Access Compliance Report

Public Rights-of-Way

(Curb Ramps)

Intersection ID: 30360	Main Street: TIMBERTOP_LN	Cross Street: WORLEY_DR	Location: SE
ADA ID: 2D2B551B128A	Ramp Type: PerpDiag	Initial Pass/Fail: Fail	Overall Compliance: No
		Severity Score: 37.5

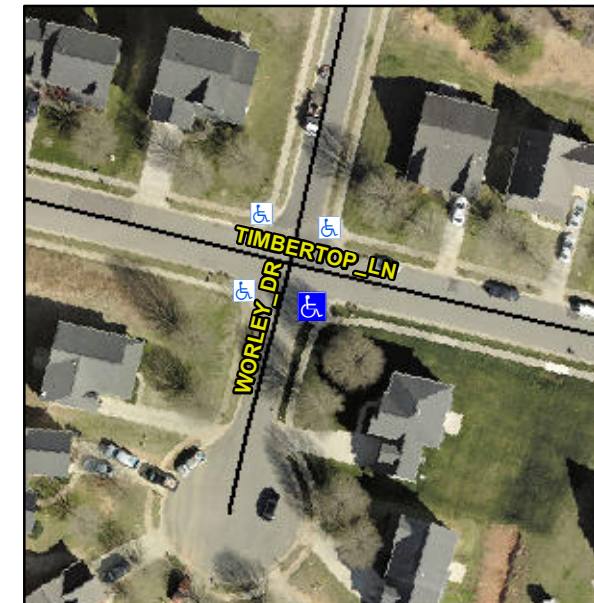
Not Found, R304.2.2, R304.5.3

Compliance	Description	Data	Compliance	Description	Data
N/A	Ramp Length (in)	75.5	No	Ramp Slope (%)	13.1
Yes	Ramp Width (in)	48.0	No	Ramp XSlope (%)	6.7
N/A	Flare Type LT	N/A	N/A	Flare Type RT	N/A
N/A	Flare Slope LT (%)	N/A	N/A	Flare Slope RT (%)	N/A
N/A	Flare Traversable LT?	N/A	N/A	Flare Traversable RT?	N/A
N/A	Landing Length (in)	N/A	N/A	DWS Provided?	N/A
N/A	Landing Width (in)	N/A	N/A	DWS Contrast?	N/A
N/A	Landing Slope (%)	N/A	N/A	DWS Length (in)	N/A
N/A	Landing X Slope (%)	N/A	N/A	DWS Full Width?	N/A
N/A	Landing Curb? (Y/N)	N/A	N/A	DWS Offset (in)	N/A
N/A	Shared Landing?	N/A			
N/A	Gutter Ponding?	N/A	N/A	Gutter Slope (%)	N/A
N/A	Gutter Lip Ht (in)	N/A	N/A	Gutter X Slope (%)	N/A
N/A	Painted X Walk1?	No	N/A	Painted X Walk2?	No
	X Walk 1 Direction	To N		X Walk 2 Direction	To NW
N/A	X Walk 1 Width (in)	N/A	N/A	X Walk 2 Width (in)	N/A
	X Walk 1 Slope (%)	3.8		X Walk 2 Slope (%)	7.2
	X Walk 1 X Slope (%)	9.6		X Walk 2 X Slope (%)	1.4

Remove & Replace Curb Ramp With Two New Directional Ramps or Equivalent.
